# KINNER SERVICE BULLETINS

E-1-11

SUBJECT: FLOAT NEEDLE SEATS NA-R5, NA-R5A, NA-R6  
STROMBERG CARBURETORS

**AIRCRAFT CARBURETOR SERVICE BULLETIN NO. 32**  
**LOCKING FLOAT NEEDLE SEATS**  
**IN NA-R5, NA-R5A AND NA-R6 CARBURETORS**

### INSTRUCTION CHART #1077

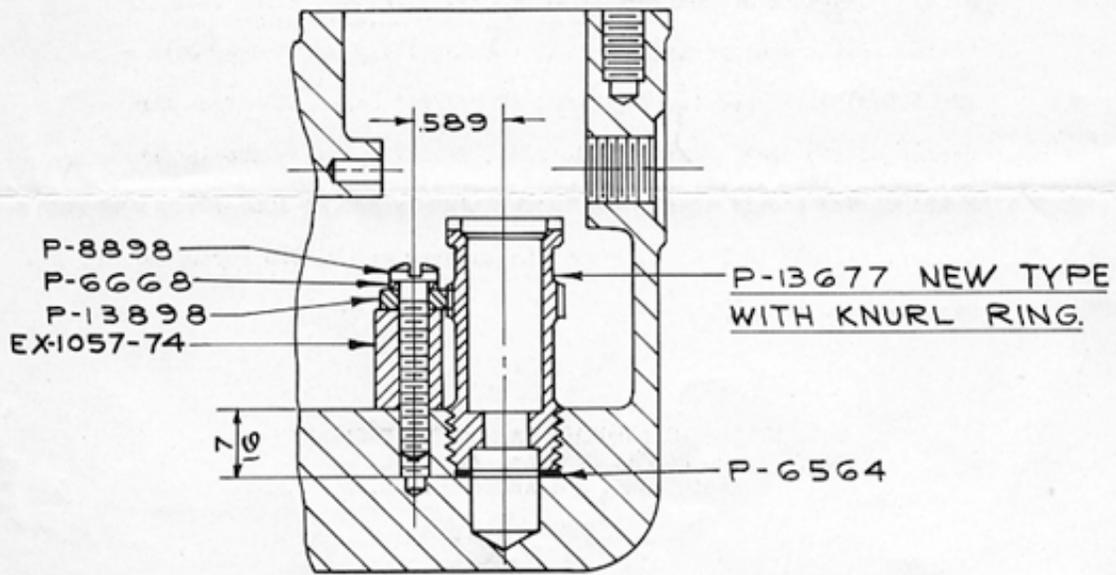
Because there is a possibility of old style float needle seats in NA-R5, NA-R5A, and NA-R6 Carburetors coming loose in service, resulting in the engine stopping, the later carburetors have been provided with a knurled ring on the float needle seat and a lock clip and screw to prevent the seat from coming loose.

Old style carburetors which do not incorporate the lock clip may be reworked in accordance with the attached sketch so that a locking device may be used with a new seat. This reworking consists of counterboring to the 7/16" dimension from the bottom of the seat gasket surface, then drilling 9/16" deep with a #25 (.149) drill and tapping #1024 NC-2 7/16" deep .589" from the center of the seat. A new style Seat, P-13677, having the latest knurled ring should then be assembled tightly and EX-1057-74 Spacer, P-13898 Lock Clip, P-6668 Lockwasher and P-8898 Screw should be assembled tightly.

INSTRUCTIONS FOR ADDING LOCKING CLIP TO FLOAT NEEDLE SEAT ON NA-R5, NA-R5A & NA-R6 CARBURETORS IN SERVICE.

1/2 DIA. C'BORE TO 7/16 DIM.  
#25(.149) DRILL 9/16 DEEP &  
#10-24 NC-2 TAP 7/16 DEEP.
